## CITY OF WASHINGTON, ILLINOIS

### Public Works Committee Agenda Communication

**Agenda Item:** Construction Standards Update

# **CONSTRUCTION STANDARDS**

City Of Washington	CONSTRUCTION STANDARD	DATE:	STANDARD NO.
		FEB. 2008	001

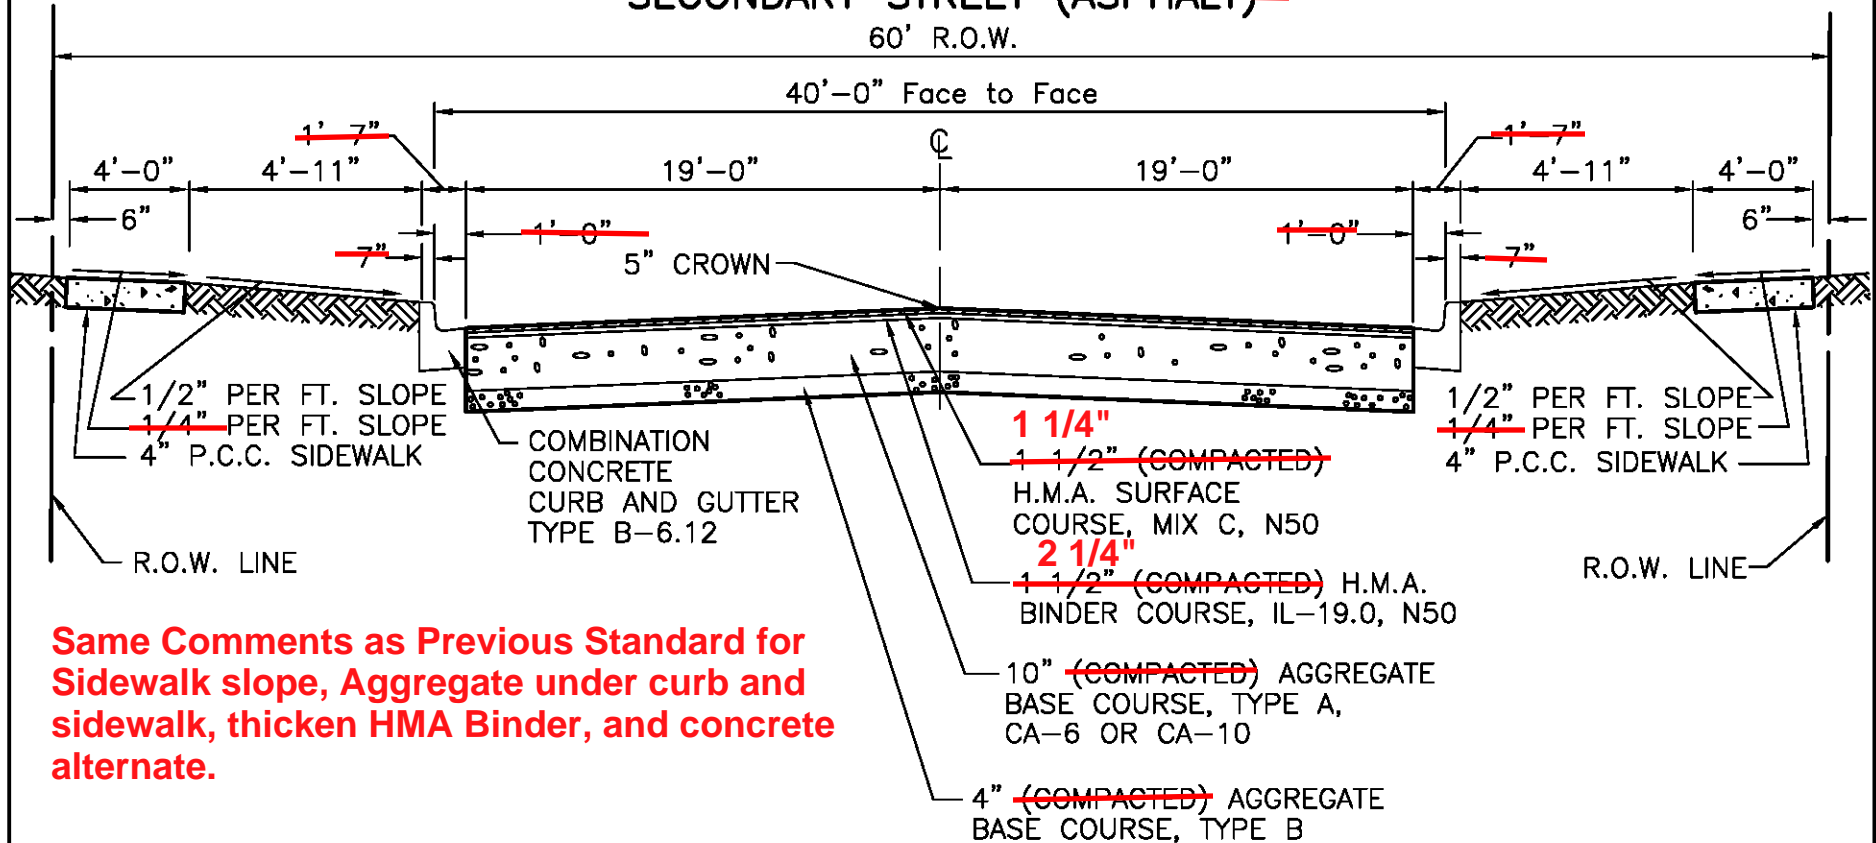
Is there a desire to add a concrete pavement alternate to residential streets? If so, I recommend 7" concrete on 4" aggregate base. More contractors do concrete paving, so there is potential for a more competitive bid. Also gives opportunity to allow for alternative bids where the contractor has to bid both asphalt and concrete which gives the City the best of both worlds to pick from.

Adjusting sidewalk slope from 1/4" per ft to 3/16" per ft is changing from 2% to 1.5%. This will help contractors from forming at 2% and accidentally exceeding causing them to tear out and redb.

Aggregate under sidewalk will help reduce future settlement and give a better working platform.

Aggregate under curb will help carry water that gets in subbase all the way to the edge of curb instead of it potentially ponding at edge of pavement.

IL-19.0 Binder placed at 1 1/2" results in cracked aggregate due to the minimal lift thickness. IDOT's recommended minimum for IL 19.0 is 2 1/4".

## ROADWAY TYPICAL SECTION SECONDARY STREET ~~(ASPHALT)~~

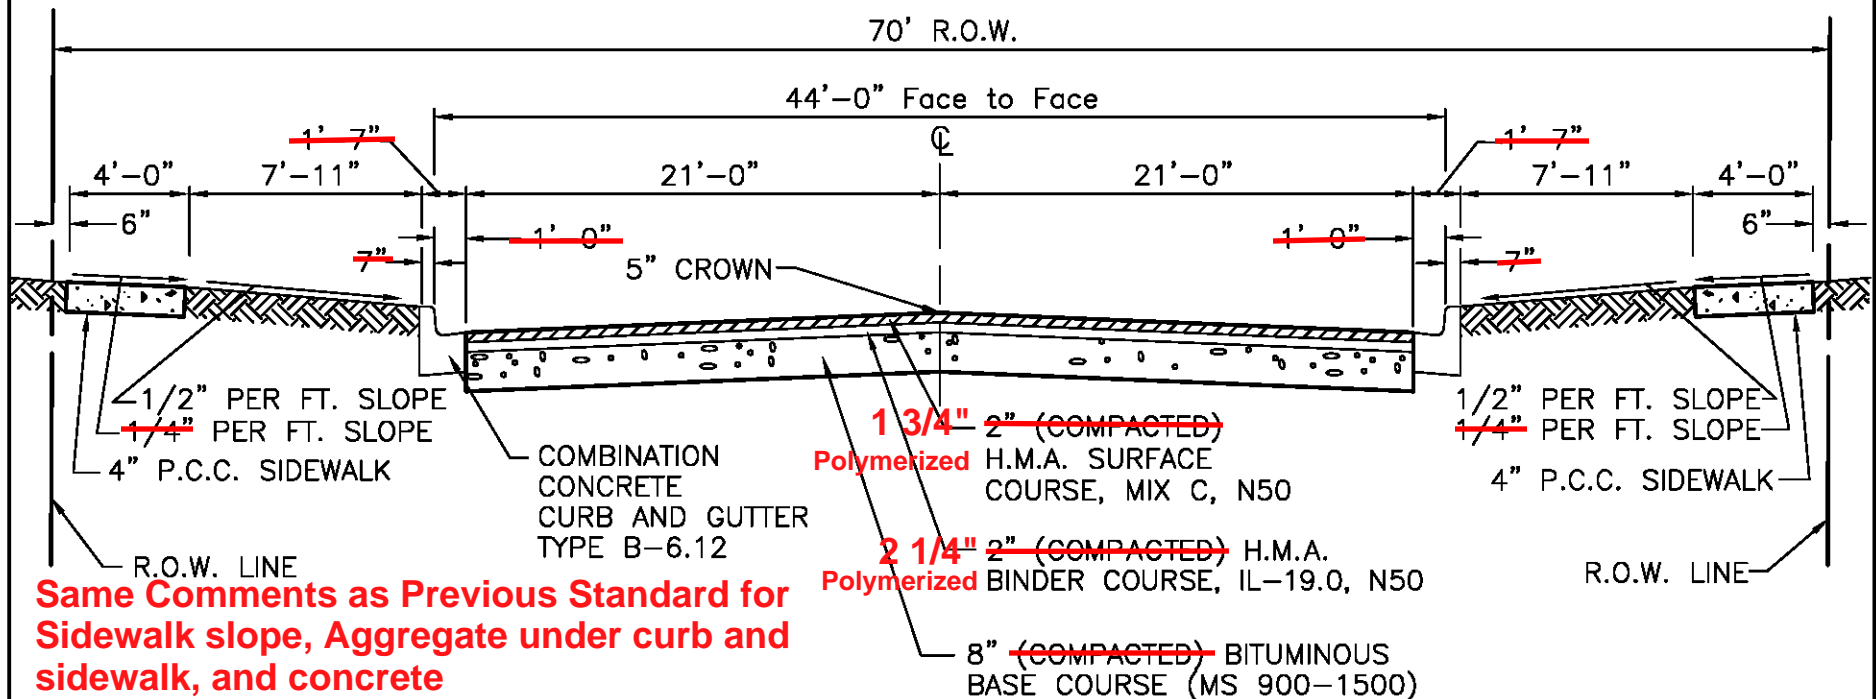
Is there a desire to add a concrete pavement alternate to residential streets? If so, I recommend 8" concrete on 4" aggregate base. More contractors do concrete paving, so there is potential for a more competitive bid. Also gives opportunity to allow for alternative bids where the contractor has to bid both asphalt and concrete which gives the City the best of both worlds to pick from.

**Same Comments as Previous Standard for Sidewalk slope, Aggregate under curb and sidewalk, thicken HMA Binder, and concrete alternate.**

- 1 1/4" ~~1 1/2" (COMPACTED)~~** H.M.A. SURFACE COURSE, MIX C, N50,
- 2 1/4" ~~1 1/2" (COMPACTED)~~** H.M.A. ~~(COMPACTED)~~ BINDER COURSE, IL-19.0, N50
- 7" ~~(COMPACTED)~~** BITUMINOUS BASE COURSE (MS 1000-1200)

# ROADWAY TYPICAL SECTION COLLECTOR/DISTRIBUTOR STREET ~~(ASPHALT)~~

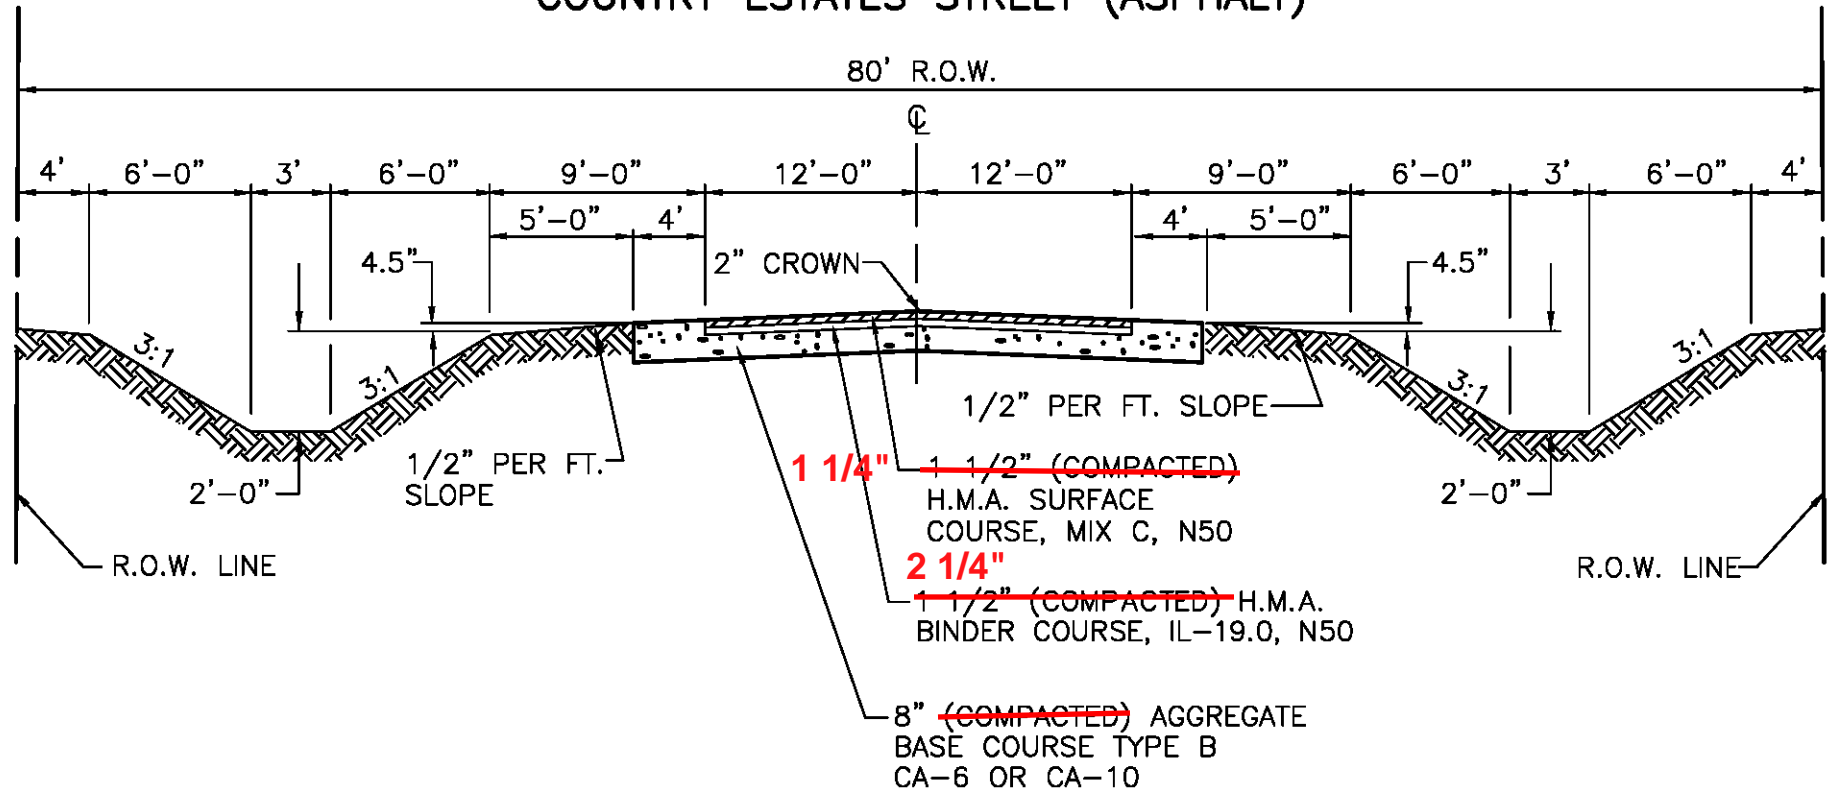
**Same Comments as Previous Standard for Sidewalk slope, Aggregate under curb and sidewalk, and concrete alternate.**

**Due to higher traffic and truck loads on collectors, Polymerized Hot-Mix Asphalt Surface would hold up better in the long run.**

**The 8" Bituminous Base Course is essentially the same as the layer above. We should rename it to 8" Hot-Mix Asphalt Binder Course, IL-19.0, N50. The top lift of binder in a polymerized pavement needs to be polymerized.**

**We should look at adding at least 4" of Aggregate to give a better subgrade to build off of.**

## ROADWAY TYPICAL SECTION COUNTRY ESTATES STREET (ASPHALT)

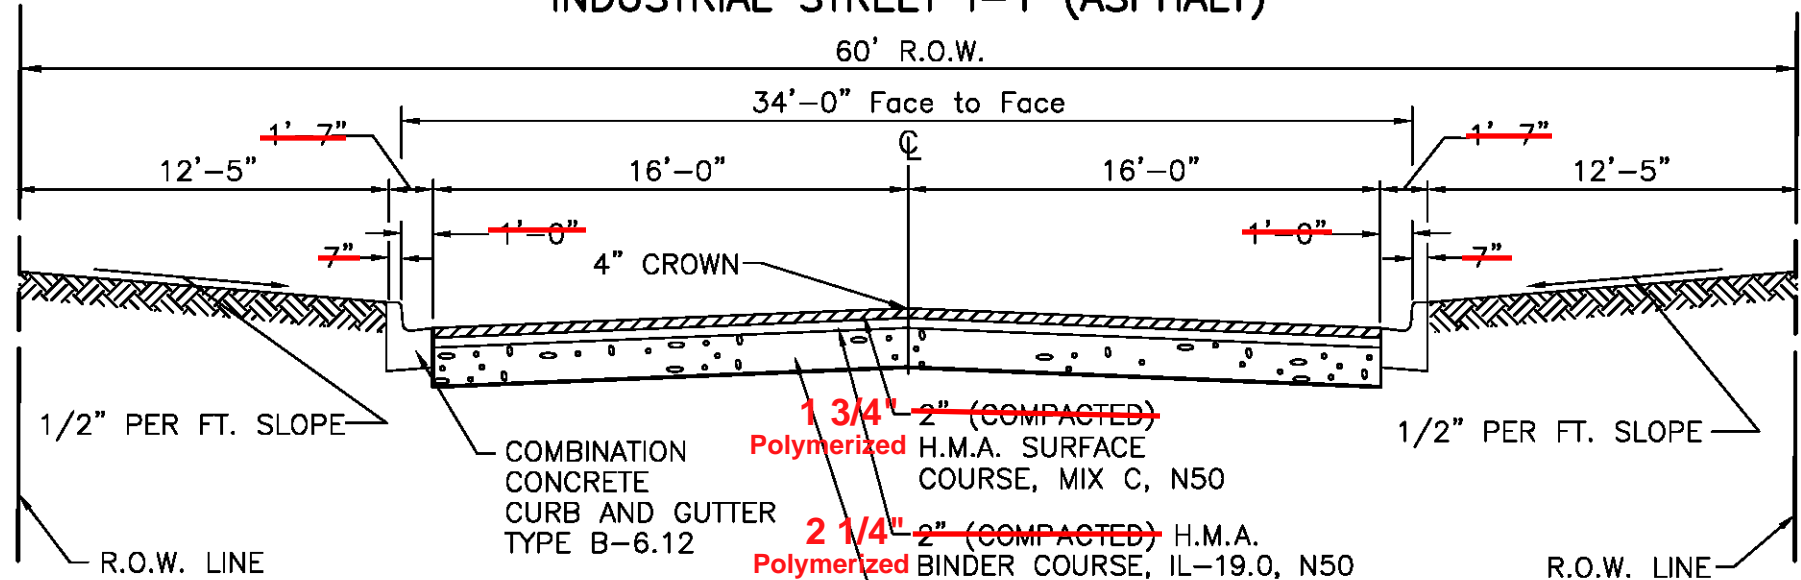
I would like to add a detail for a "Safety Edge" for asphalt with aggregate shoulders. This would essentially show the edge look more like a pyramid. The aggregate shoulder would cover this wedge of asphalt, but it helps with oversteering accidents when people drift off the roadway.

# ROADWAY TYPICAL SECTION INDUSTRIAL STREET I-1 (ASPHALT)

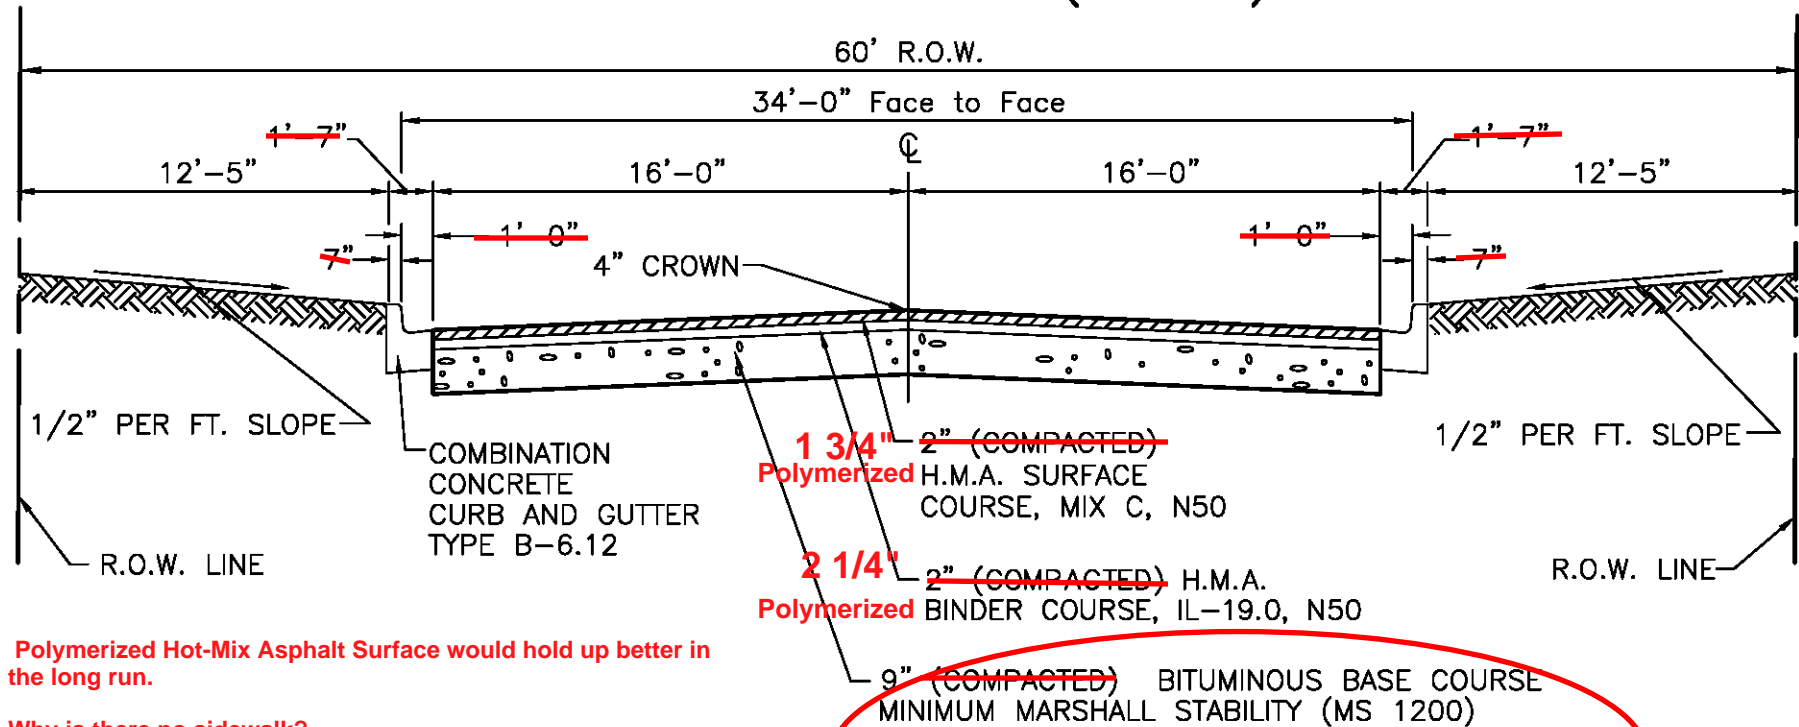
Polymerized Hot-Mix Asphalt Surface would hold up better in the long run.

The Bituminous Base Course should be renamed to Hot-Mix Asphalt Binder Course, IL-19.0, N50

Why is there no sidewalk?

We should look at adding atleast 4" of Aggregate to give a better subgrade to build off of.

# ROADWAY TYPICAL SECTION INDUSTRIAL STREET 1-2 (ASPHALT)

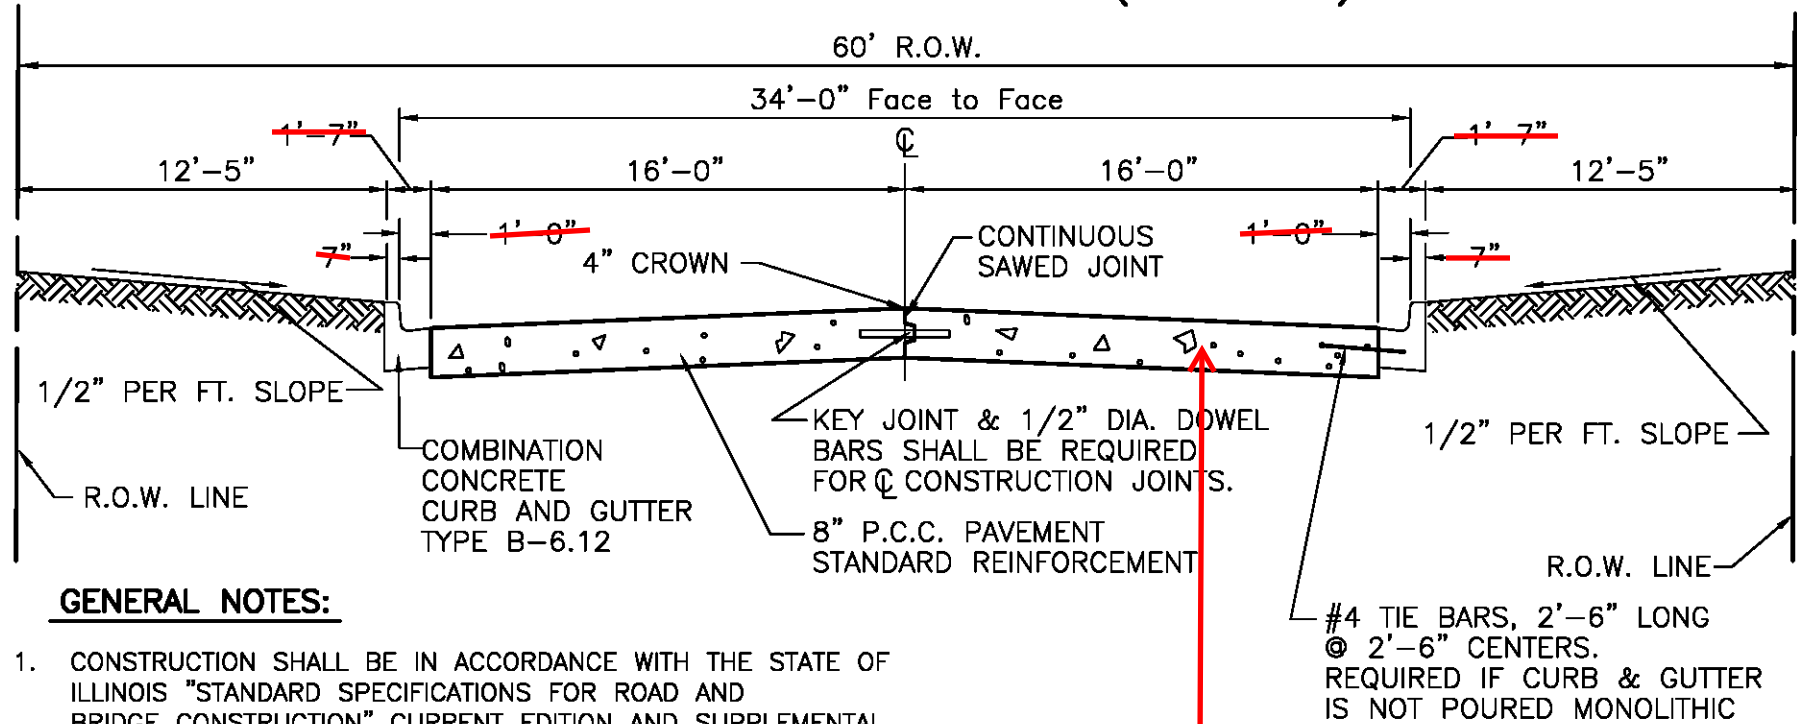
Polymerized Hot-Mix Asphalt Surface would hold up better in the long run.

Why is there no sidewalk?

We should look at adding atleast 4" of Aggregate to give a better subgrade to build off of.

Bituminous Base Course renamed Hot-Mix Asphalt Binder Course, IL-19.0, N50 and add an \* before it denoting this and the PCC Base Course are Alternates.

## ROADWAY TYPICAL SECTION INDUSTRIAL STREET I-1 & I-2 (CONCRETE)

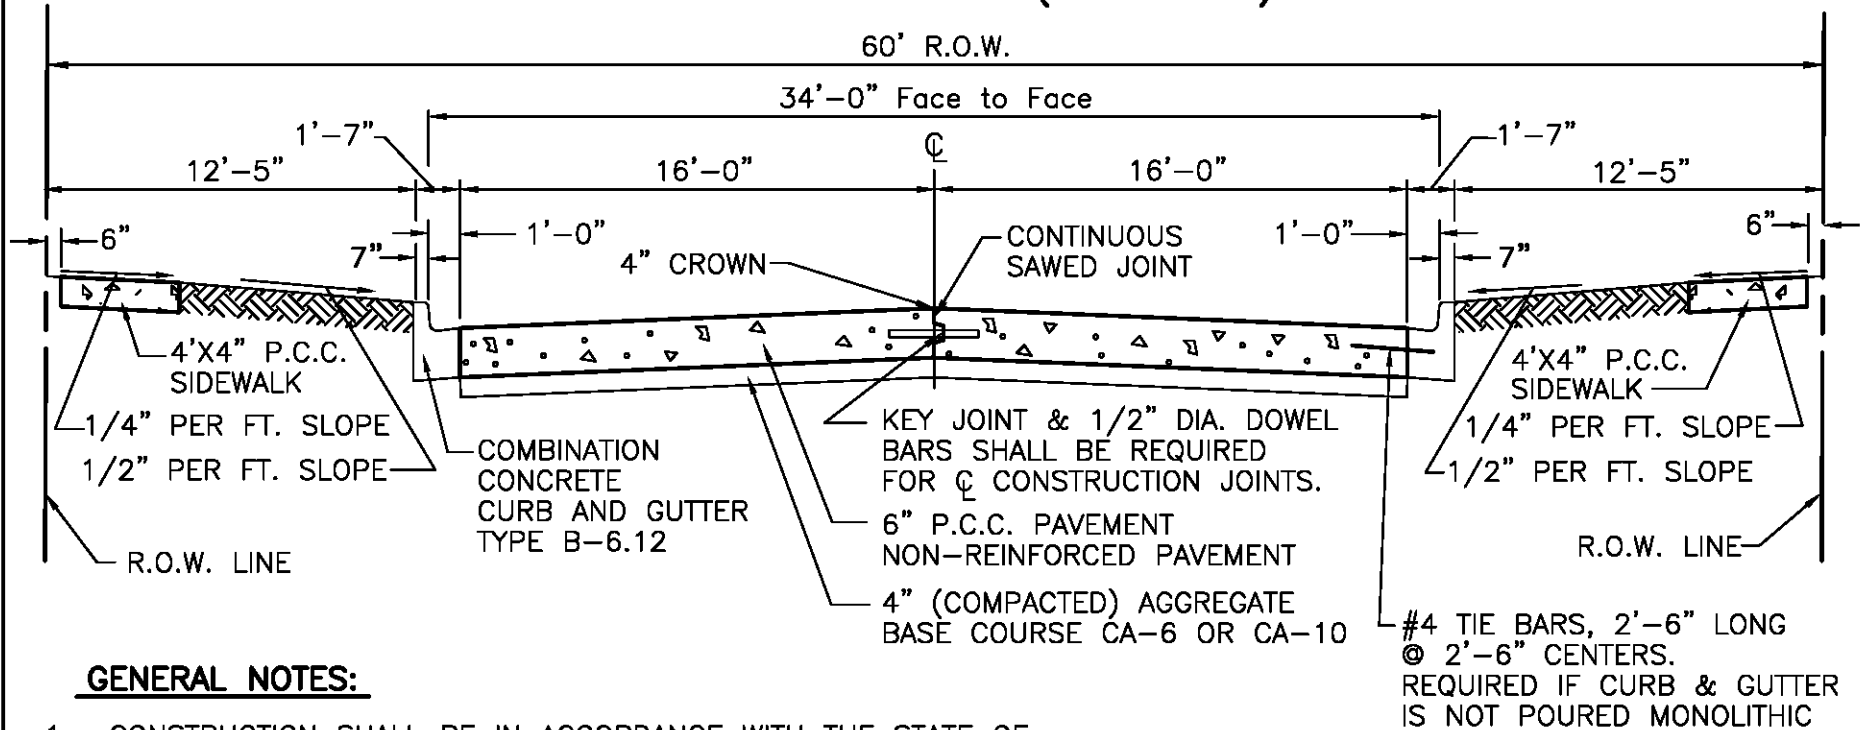
We should show another dowel bar here with a sawed joint. Getting widths longer than 12' starts to increase the chance of uncontrolled longitudinal cracks.

We should also look to add a standard for non-reinforced concrete pavement as well as a joint detail for that. or We can add to the general notes to follow IDOTs Standards BLR 10-7 and BLR 14-12

We should also look to add a standard for reinforced concrete pavement as well as a joint detail for that.

Should there be sidewalk added to this?

Add 4" aggregate under pavement extended under curb as well.

Update with  
most recent  
IDOT  
information

## ROADWAY TYPICAL SECTION COUNTRY ESTATES STREET (CONCRETE)

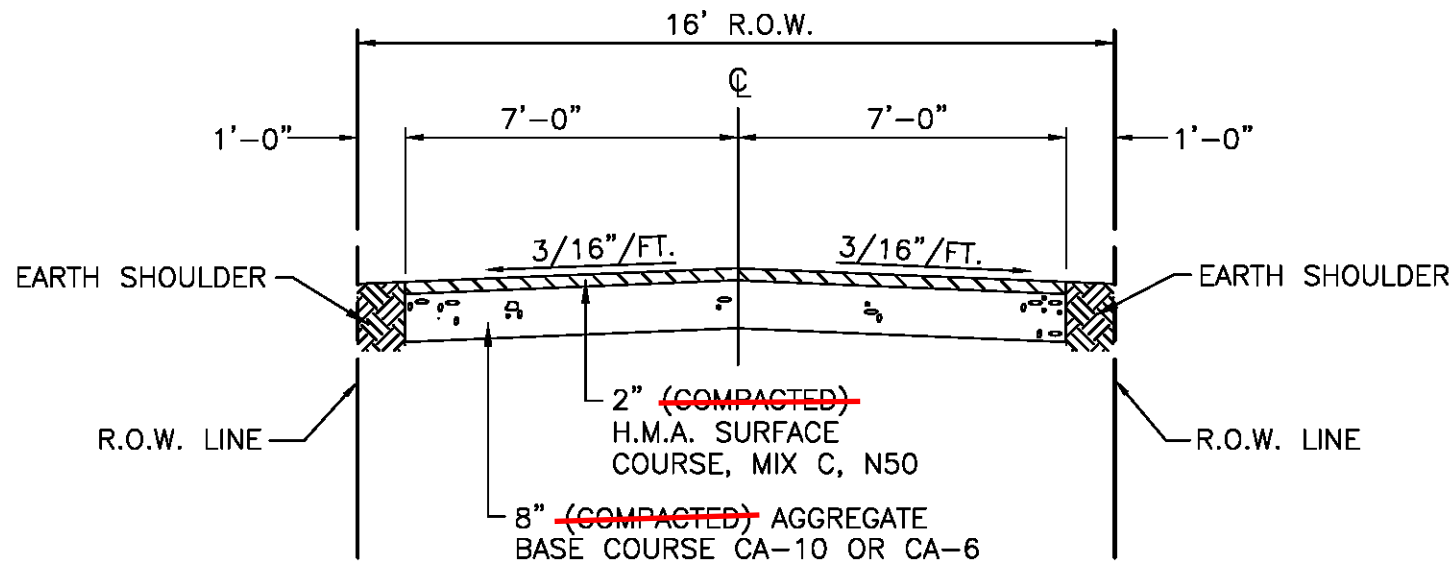
Extend aggregate through the shoulder to maintain subgrade drainage.

Add 4" topsoil to the callout for the ditch section.

Add General note that Fertilizer shall be applied according to Section 250 of the Standard Specifications.
